Amendment Notice 1

Licence Number L6217/1983/15

Premises Wagerup Alumina Refinery

Date of Amendment 26 July 2019

Figure 2: Spillway Design

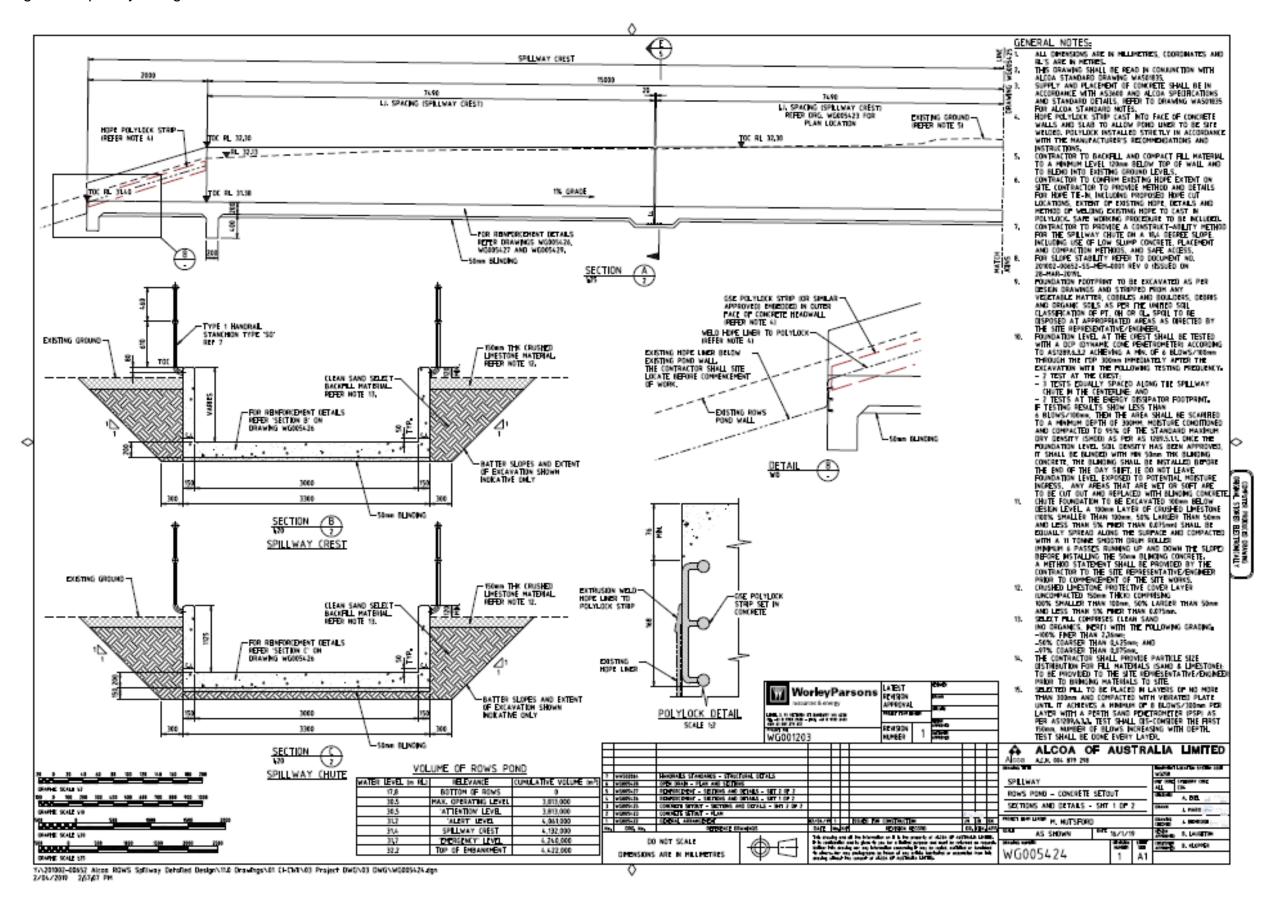
| Infrastructure | Design and construction requirements | Infrastructure location | <u>Timeframe</u> |
|-----------------------|--------------------------------------------------------------------------------------------------------------------------------------------------------------------------------------------|----------------------------|-------------------------------|
| ROWS pond spillway | In accordance with final designs in Figure 2 and Figure 3 in Schedule 1 In accordance with ANCOLD Guidelines on Tailings Dams, Planning, Design, Construction, Operation and Closure 2012 | As shown in Schedule 1 | Before 31 December 2019 |
